Value Engineering For Transportation Improvements

I-95 (SR 9) Interchange at Northlake Boulevard

Value Engineering Study Final Report

Project Description: I-95 (SR 9) Interchange at Northlake Boulevard

RECOMMENDATION No. 1: Build Alternative No. 1 with a Partial Cloverleaf in the Northeast Quadrant.

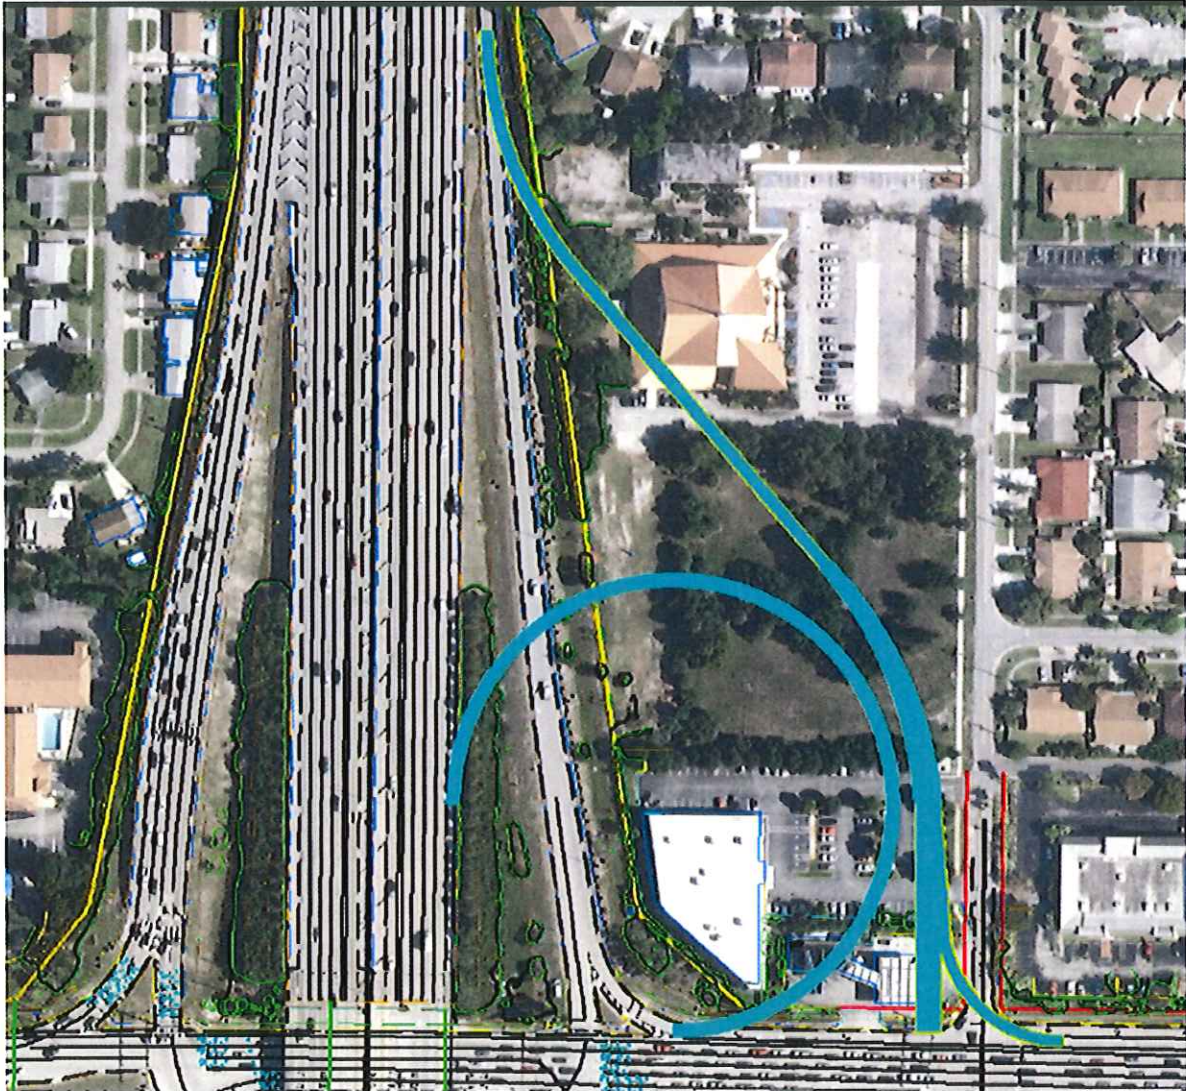
The PD&E Documents show a Diverging Diamond Interchange (DDI) as Alternative No. 2.

The preliminary traffic modeling showed that the design year condition of the northbound to westbound off-ramp movement was improved. However, other impacts from this change will need to be investigated, such as its effect on the signalized or free flow movements of the northbound to eastbound right turn movement.

VE Recommended Change: Construct PD&E Alternative No. 1 with a partial cloverleaf in the northeast quadrant and do not widen the southeast off-ramp. Potential cost savings \$16,555,000 when compared to the PD&E Proposed Alternative 2 Diverging Diamond Interchange (DDI) cost, however it will increase the cost of Alternative 1 Modify Concept with additional right of way and construction costs.

PD&E Design Response: Not Accepted

RECOMMENDATION No. 2: Realign the ramps closer to the mainline

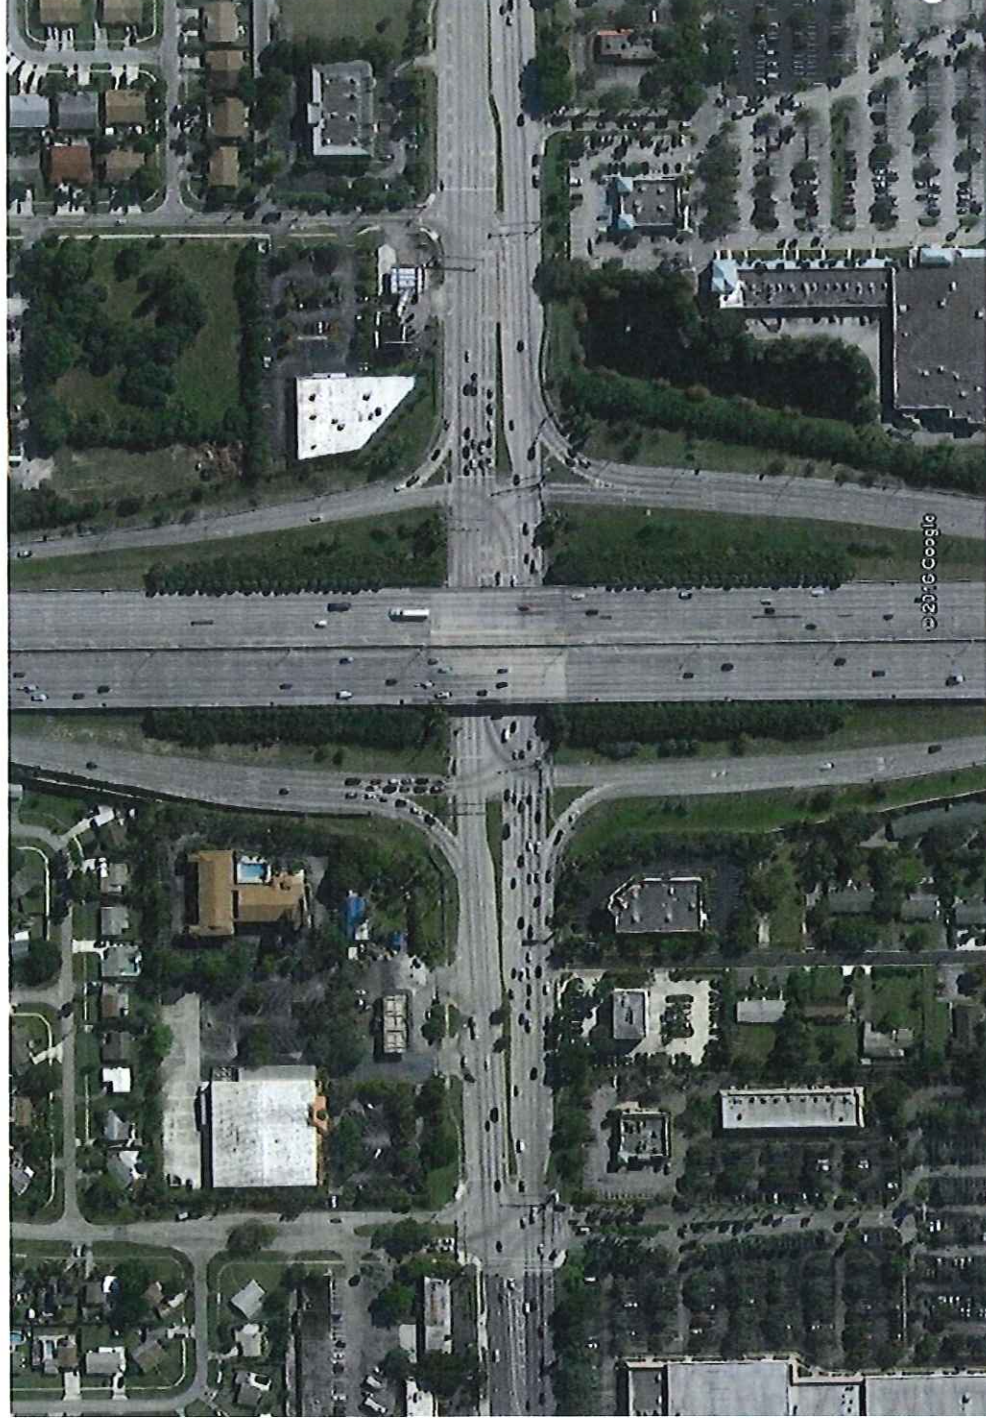
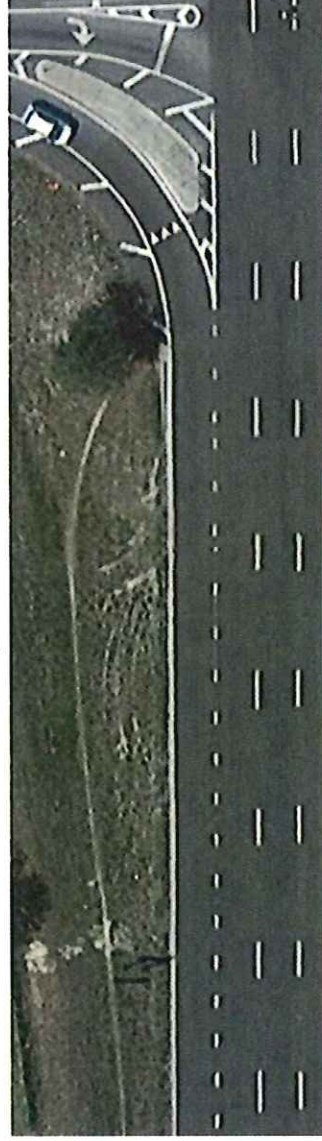
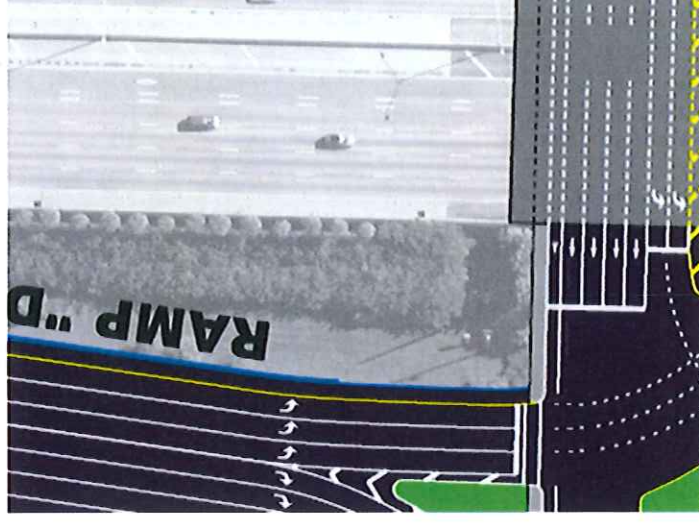
The PD&E Documents show a Diverging Diamond Interchange (DDI) as Alternative No. 2.

Construct Alternative No. 1 and re-align exit ramp "D" closer to the mainline highway. Add one restrictive free-flow lane.

VE Recommended Change: Construct Alternative 1 Modified Concept and re-align exit ramp D (SB Exit) closer to the mainline interstate. Add one restrictive free-flow lane. Potential cost savings is \$30,714,000 when compared to Alternative 2 DDI cost.

PD&E Design Response: Not Accepted

The exit-ramp will be widened to provide triple-lefts and triple-rights. The VE free-flow right turn effectiveness would be negated by the queuing vehicles at the Keating Drive signal located 380 ft. from the right turn lane. The PD&E proposed right turn lane at Keating Drive would not function due to the volume of ramp traffic free-flowing onto Northlake Blvd, therefore the right turn lane at Keating Drive would be eliminated. Keating Drive is the only neighborhood access from Northlake Blvd. and the right turn lane at Keating Drive is needed. The free flow turn creates new conflicts with the pedestrians and bicyclists.

RECOMMENDATION No. 3: Create free flow off ramp right turns for Alternative 1

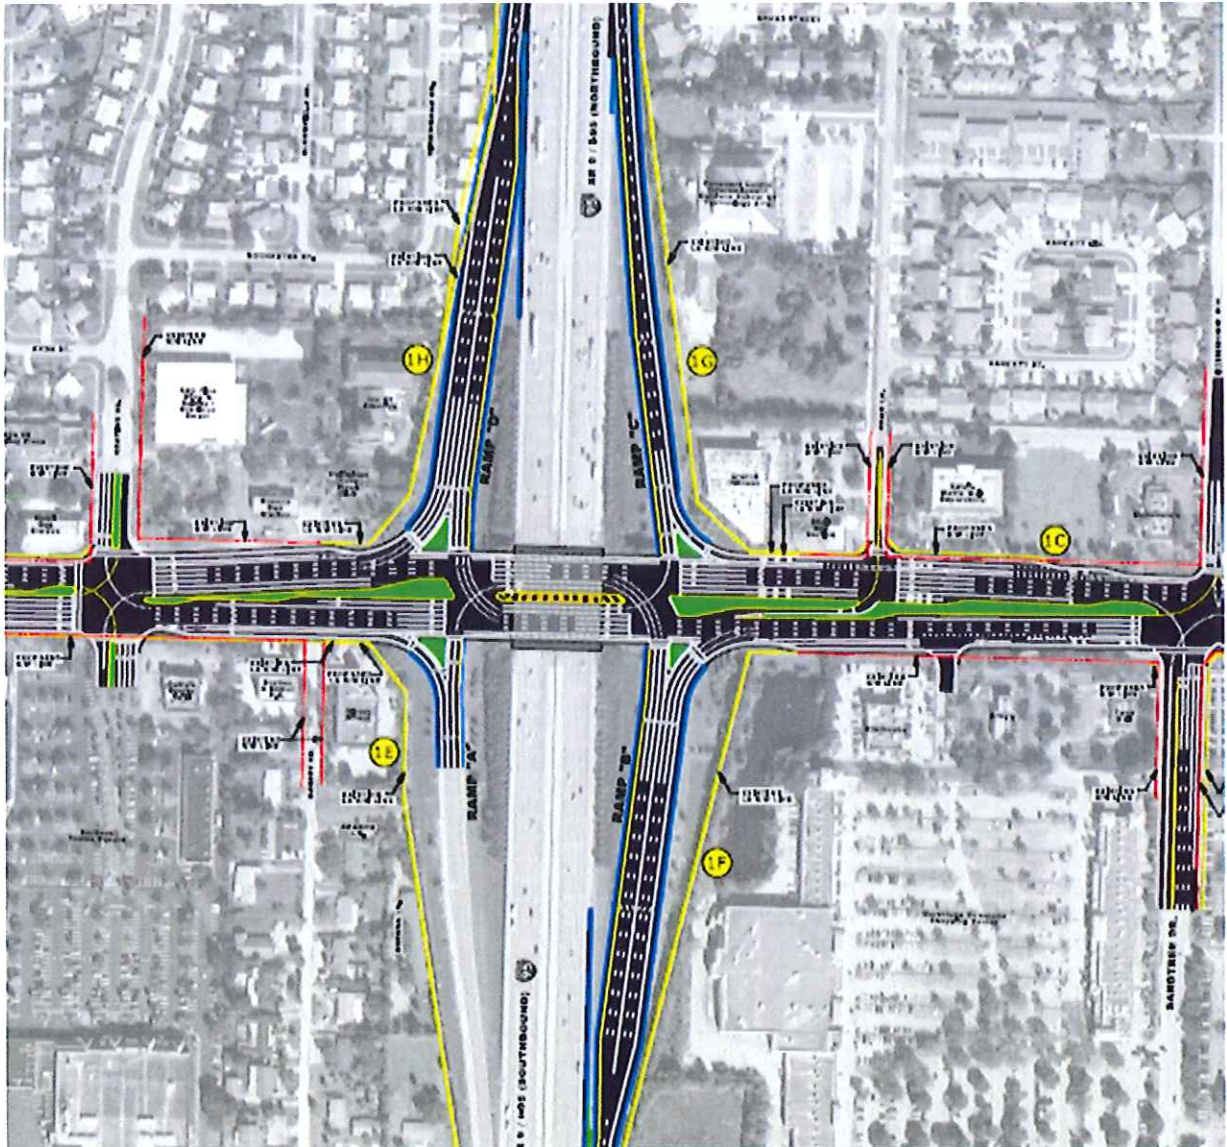
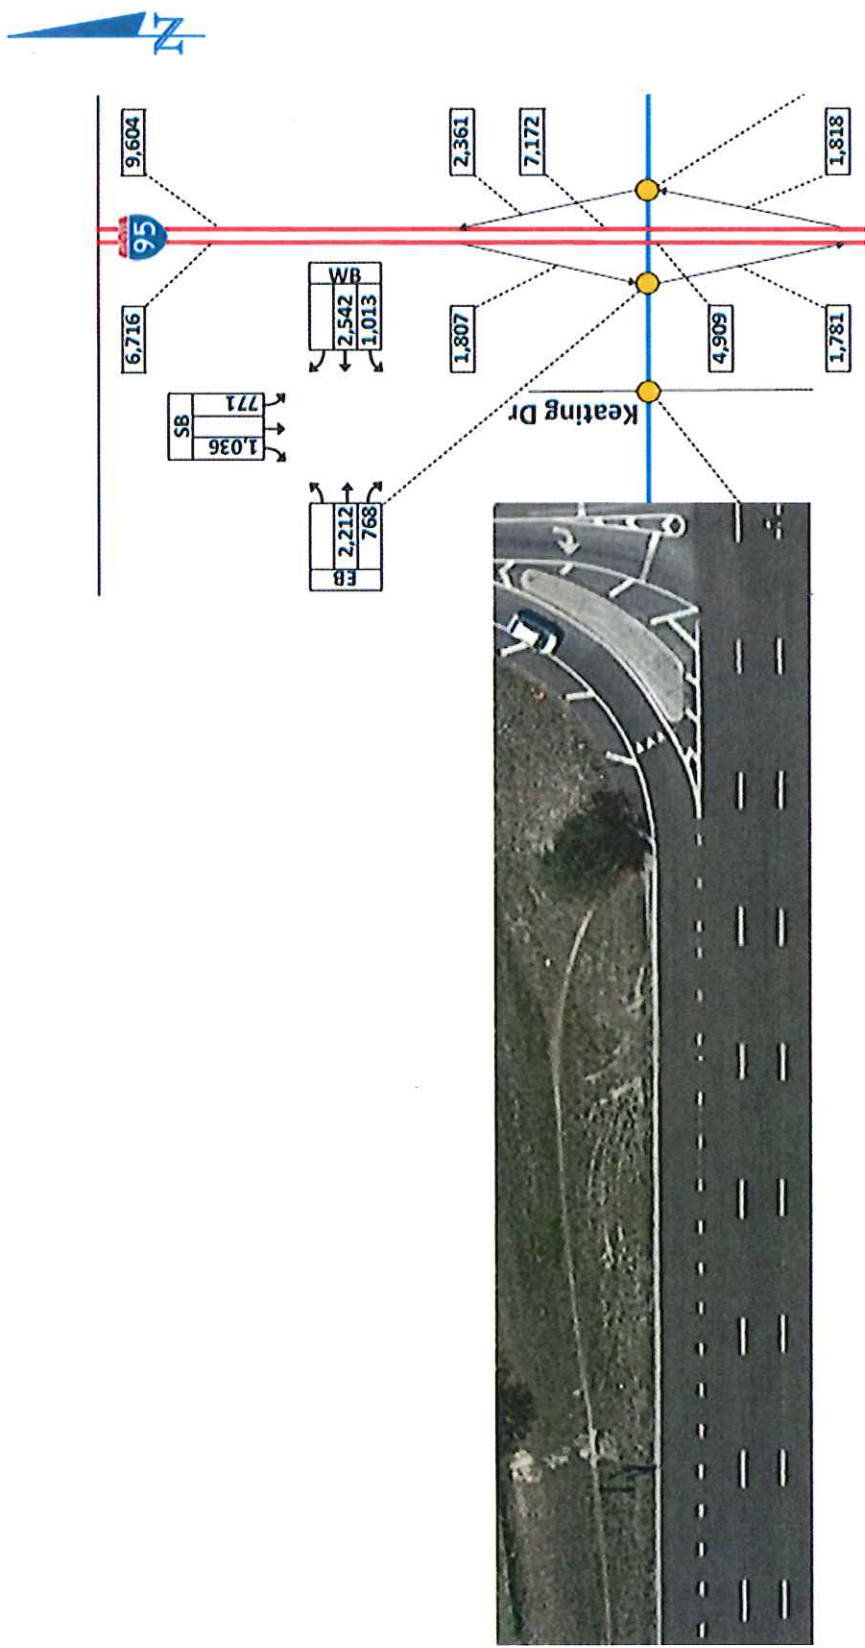
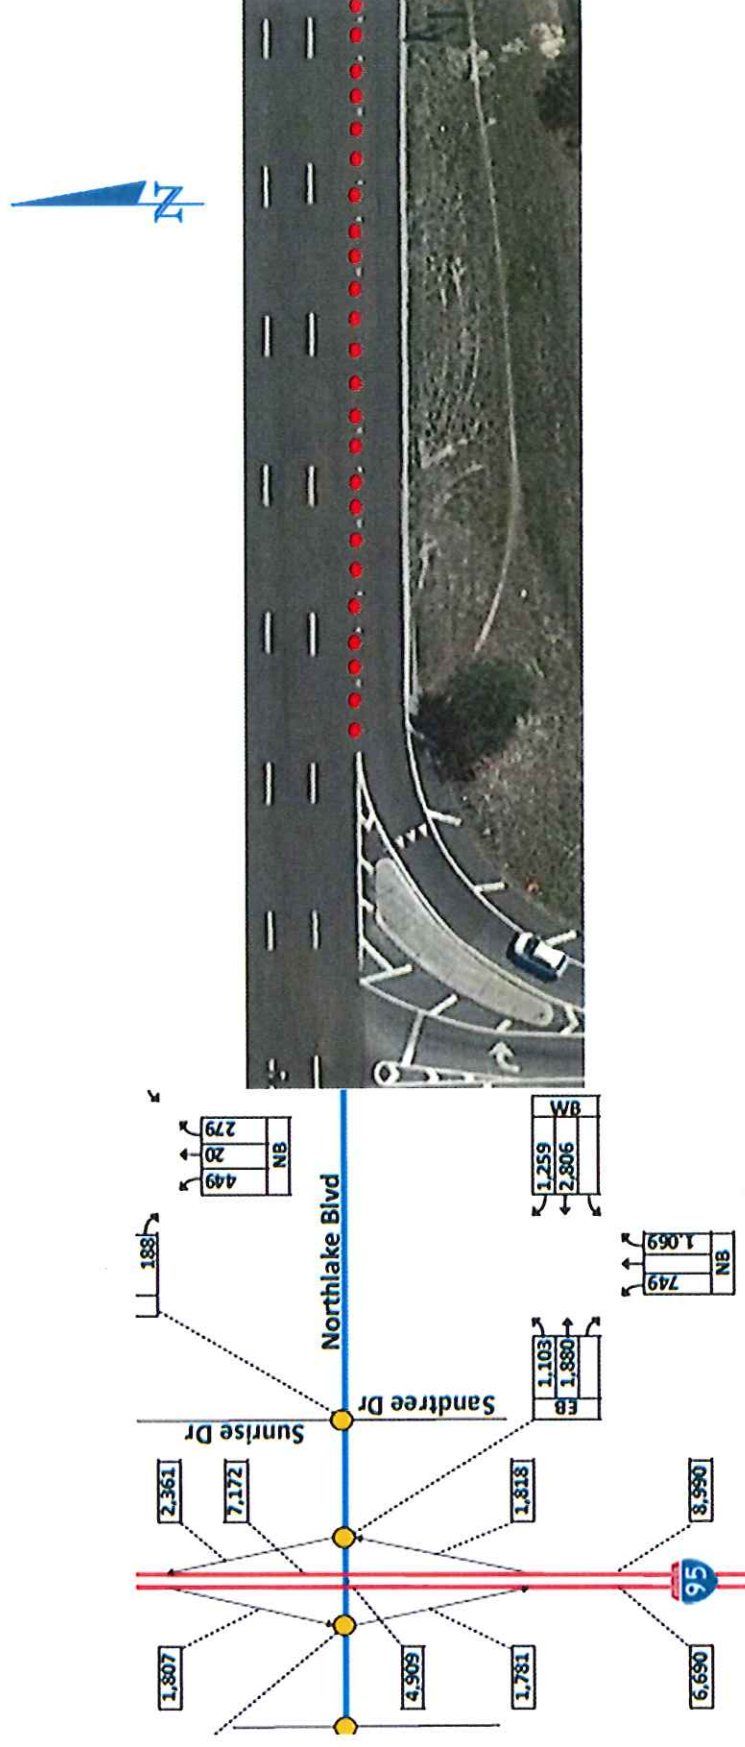
We presumed an improvement in the evaluation results provided in Table 2 for Alternative 1. Therefore acceptable level of service for all of the ramp terminal approaches are expected. Nonetheless the northbound left turn movement at the NB ramp terminal for the 2040 design year results in a LOS E. Similarly this build alternative will provide adequate storage to accommodate the queues along the ramps without backup into the I-95 mainline compared to the No-Build condition. However, this alternative will require realignment and extension of the existing northbound and southbound off-ramps to accommodate the 2040 design year queues. This results in right of way impacts to the residential properties in the northwest quadrant of the interchange.

- Less construction cost
- Less right-of-way cost
- No impact to I-95 mainline (no bridge reconstruction)
- Easier to construct.
- Grater public acceptance
- This alternatives will provide acceptable LOS for all of the ramp terminal approaches.
- Less impact to access from business and side streets connecting to Northlake Blvd.
- The overall queue lengths could be improved from 0.38%, and 0.16% to greater percentages as to be determined by new traffic simulations in the I-95 southbound off-ramp, and in the I-95 northbound off-ramp respectively.

VE Recommended Change: Create free flow off ramp right turns for Alternative 1 Modified Concept Potential cost savings of \$29,137,000 when compared to Alternative 2 DDI cost.

PD&E Design Response: Not Accepted

There are geometric, operational and right of way concerns with the introduction of a northbound to eastbound free flow right turn into Alternative 1 Modified Concept. To operate effectively the right turn lane at the shopping center should be closed, thereby rerouting all shopping center traffic to Sandtree Drive. The distance to Sandtree Drive is 700 feet. However, the 2040 Build queue length for the westbound right turn at Sandtree Drive is 389 feet which leaves 311 feet for the traffic weaving distance. The weaving distance is inadequate to handle the left merge and right merge prior to the outside lane becoming right turn only at Sandtree Drive. FDOT eliminated the free flow right turn condition at the exit ramp signal in prior intersection projects to improve operations and safety conditions.

RECOMMENDATION No. 8: Build the 35 MPH Diverging Diamond Interchange

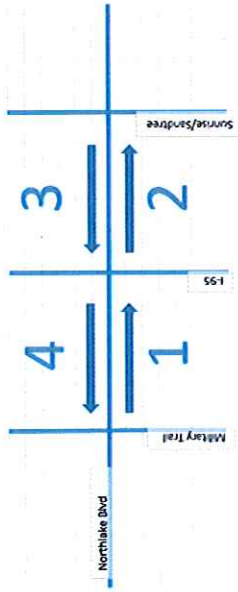
The PD&E Documents show a 40 MPH Diverging Diamond Interchange (DDI). The plan includes lengthening the bridge structure over I-95, and extensive right of way takes along Northlake Boulevard. The plan provides the greatest level of service compared with the other alternatives.

- Lower capital costs
- Less required new right of way
- Reduces delays on the I-95 ramps
- No change in environment impact
- Stakeholder acceptance does not change
- Constructability is better
- Future maintenance is similar
- Pedestrian amenities remain the same
- No lengthening of I-95 bridge structure

VE Recommended Change: Construct a DDI at a lower speed limit (35 mph), in place of the proposed Alt 2. This proposal does not require the I-95 bridge structure to be lengthened and requires less right of way to be acquired. The reduced cost of this construction provides the same level of service as the 40 MPH DDI, but is not as intrusive on the neighboring properties. The potential cost savings is \$44,750,000 when compared to PD&E Alternative 2 DDI.

PD&E Design Response: Not Accepted
